Attention: Diane Fajmon
Application reference number: MP 10_0111

Subject: GreenWay Submission from Bicycle NSW

Bicycle NSW submission

Sydney Light Rail Extension - Inner West, Dulwich Hill to
Lilyfield

| BNSW Fig C: Marion Stop to Taverners Hill Stop |

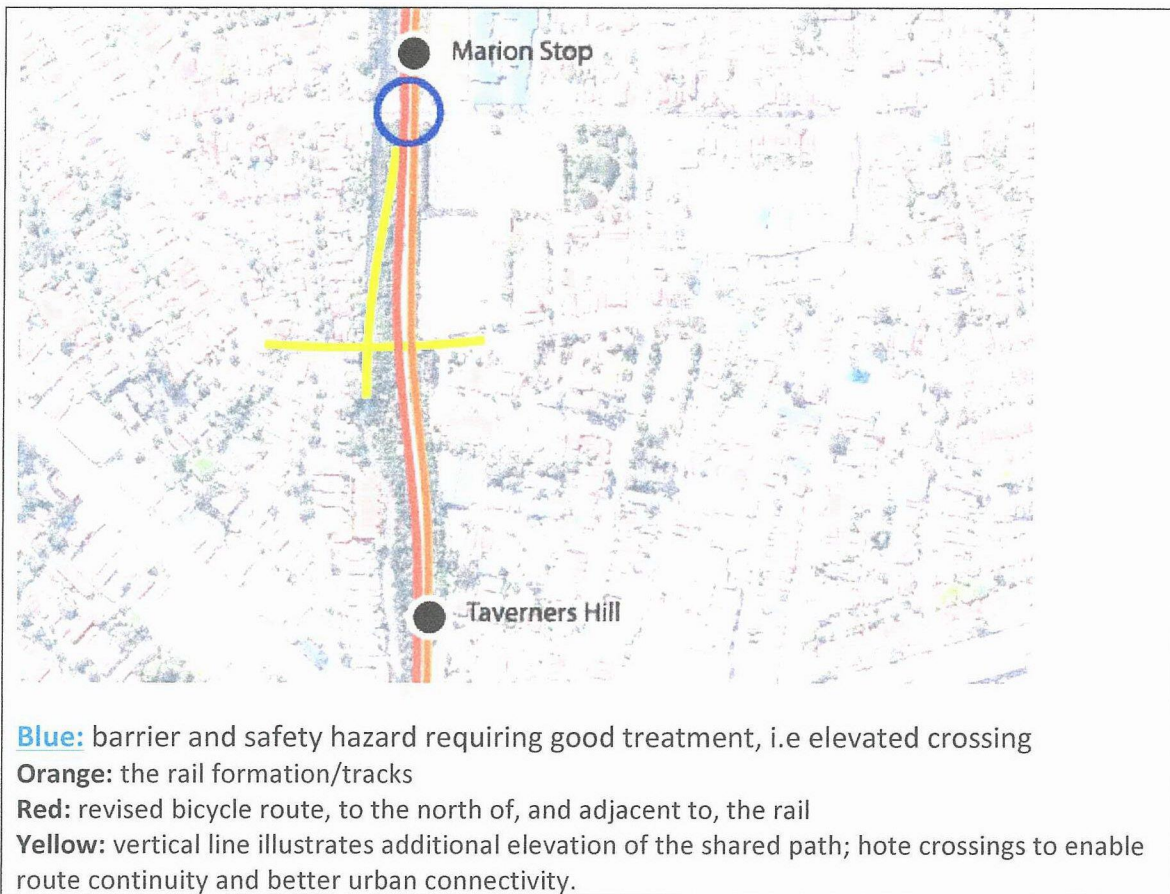
BNSW Fig C below shows BNSW's recommended extension of the elevated shared path as the REVISED design of the GreenWay in red, from its proposed end point just 100m north of Taverners Hill Stop. This would enable people using the shared path to retain their elevation, more easily crossing over Marion Street. The vertical yellow line is the ramp.

BNSW Fig C below shows a blue circle over the intersection of the Greenway path with Marion Street. Marion Street operates as a major barrier and hazard to people.

Within the section Marion to Taverners Hill, the Project proposes a new signalised crossing on Marion Street as the “GreenWay component”, a “refinement” from the *Strategic Concepts Report*. This is a major concern to BNSW.

The signalised crossing of busy Marion Street, proposed by the Project, is not a good treatment in:

- Demanding a significant increase in physical effort by people walking and riding bicycles to change elevation (Rotherham, Parkin 2010).
- Delaying people using the shared path and deterring their use of the GreenWay.
- Reducing opportunities for transport choice.
- Detouring people away from desire lines and destinations to the East.

A superior crossing of Marion Street (safer, greater amenity (Parkin, Rotherham 2010)) could then service, even at a later stage, the continuation of the shared path along BNSW's much-preferred alignment. This alignment would be adjacent to the light rail, on its western side providing a more direct route to Eastern destinations– described as BNSW REVISED route in the **CBD Cycling Link** Appendix 1.

The proposed design has the whole path ramping down from Taverners Hill to the Marion St road grade as it heads North. BNSW **recommends** that the GreenWay path continue at-grade with the rail line but that an extra ramp be provided for access down to Lord Street. However, the ramp should be reversed to provide optimal access for cyclists travelling to/from the city rather than to/from Dulwich Hill.

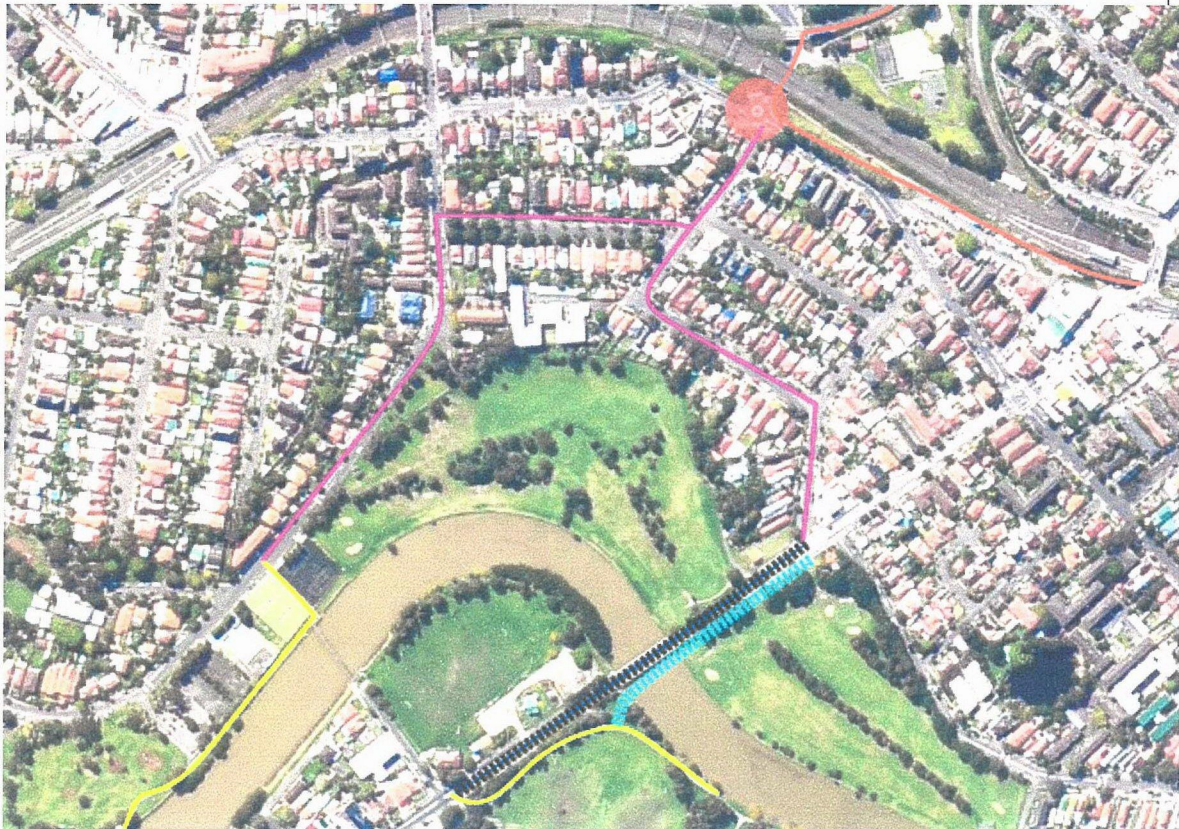
Turning left along Ewart St provides access to Dulwich Hill Station/Stop. The EA suggests that cyclists join the local road network at this point, however, this introduces two unnecessary crossings of motorised traffic on Ewart St for a mere 100m of travel. Also, Ewart Ln and the adjacent car park only allow Eastbound traffic flow and do not provide a Westbound facility for pedestrians/cyclists. The Wardell Rd rail overpass also provides very inadequate facilities for people walking or cycling (1m paths).

Bicycle NSW **strongly recommends** that a separated GreenWay path continues on the North side of Ewart St and along the North boundary of the car park from Terrace Rd to Dulwich Hill Station/Stop along the rail reserve.

BNSW also **recommends** additional work done to the Wardell Rd rail overpass at Dulwich Hill Station/Stop to provide additional width for people walking and cycling.

FIGURE 2: SECTION A: ROZELLE GOODS YARD TO BALMAIN RD

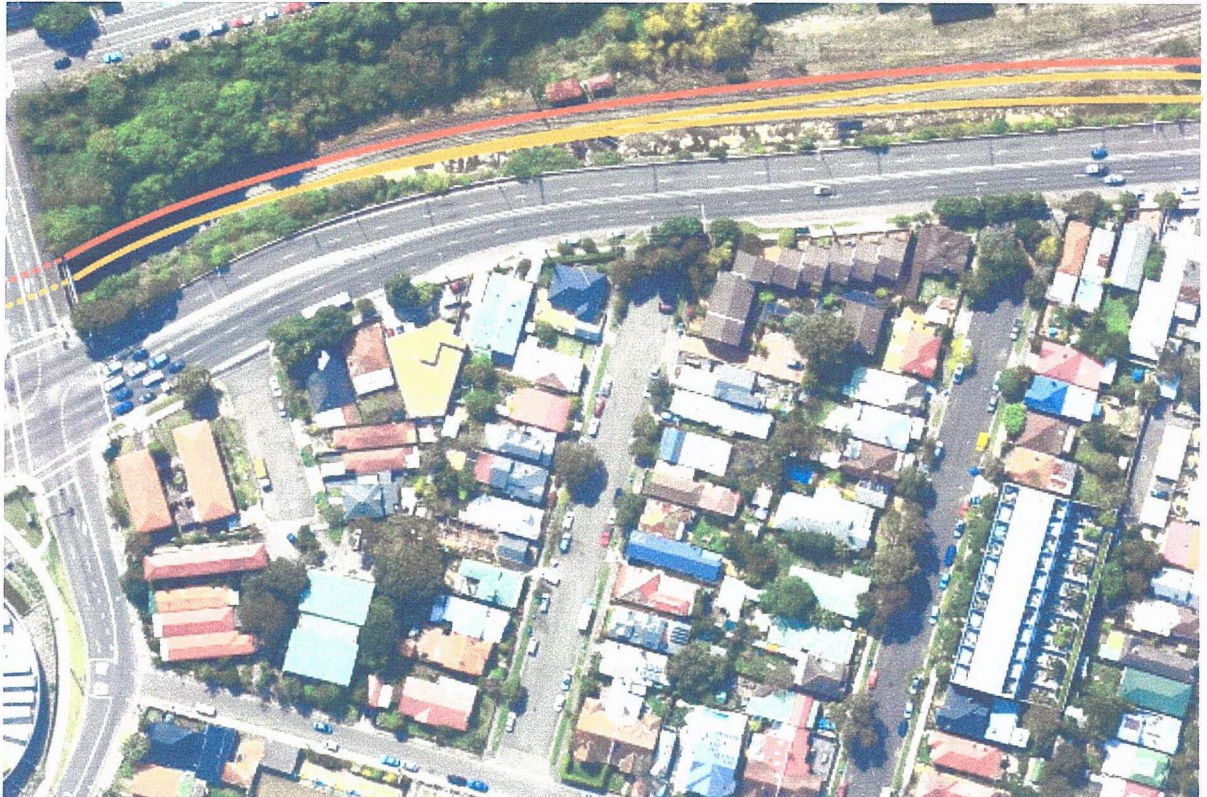
The following diagram shows the double rail tracks (orange) merging into a single rail track (orange) as they enter the narrow cutting at the West end of the Rozelle Goods Yard. This leaves room for the Greenway path (red) to enter the cutting adjacent to the rail line and pass beneath Balmain Rd (dotted lines on the left).

FIGURE 6: SECTION A: ROZELLE GOODS YARD TO BALMAIN RD

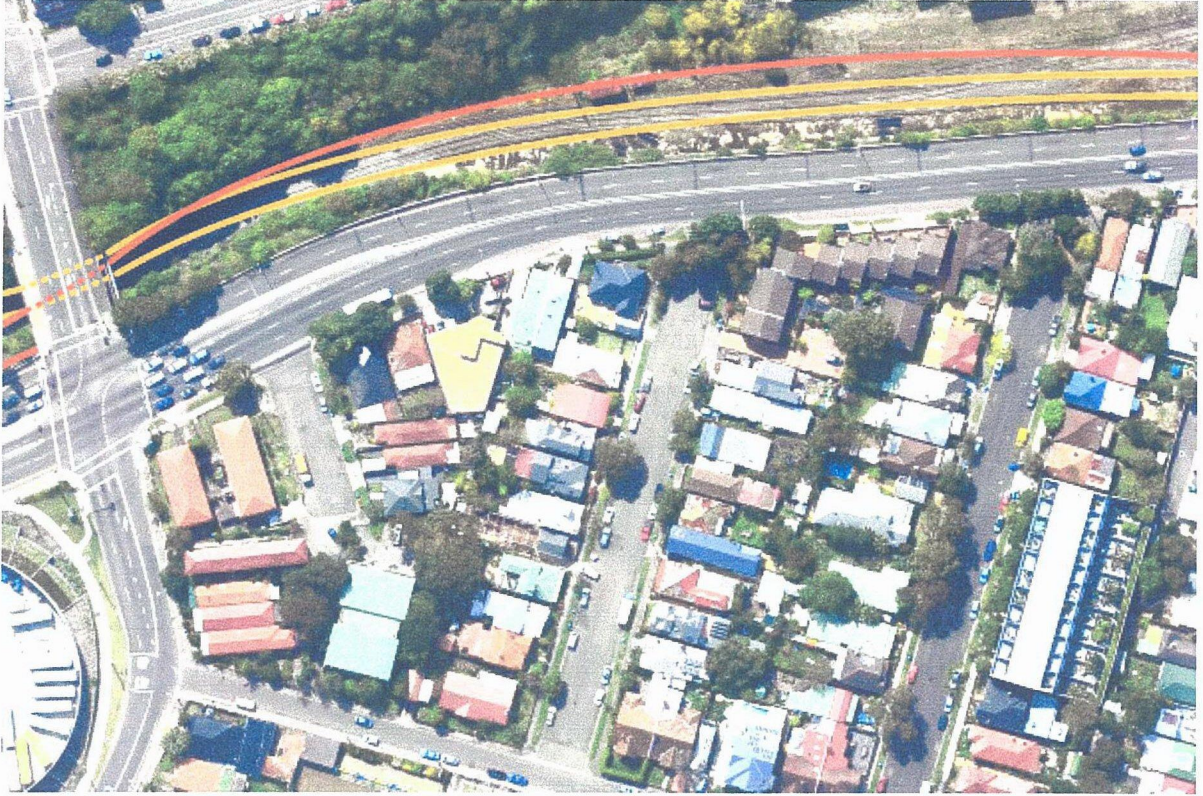
The following diagram shows the Westbound double rail tracks (orange) heading towards the narrow cutting at the West end of the Rozelle Goods Yard as the Greenway path (red) begins to rise above the railway grade. At Balmain Rd (on the left), the Greenway path will have reached a sufficient elevation to cross above the rail tracks but still pass under Balmain Rd.

Figure 10: CBD Link – Stage 2

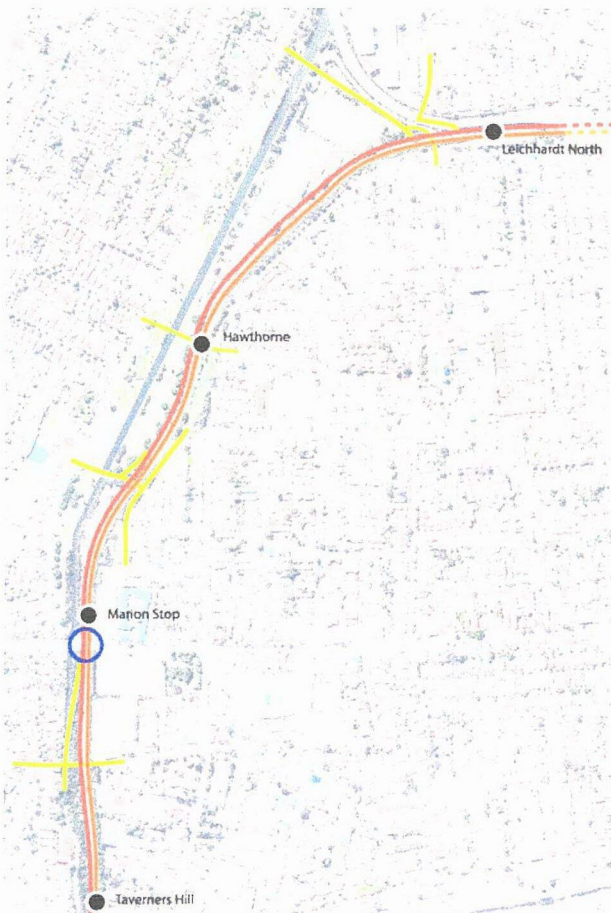
Unfortunately, the EA proposes to use an 'orange' corridor option along the Hawthorne Canal which provides far poorer access to the Sydney CBD. Even if it is not possible for the Greenway path to use the City West Link Tunnel, the *CBD Link – Stage 2* is vital for cyclists wishing to use the Greenway path to access the Sydney CBD.

This tunnel is only wide enough to accommodate the two light rail tracks. The provision of a continuous Greenway through the City West Link Tunnel would require either: significant excavation to widen the tunnel (prohibitively expensive) or a reduction in the light rail facilities to a single-track line for a short section.
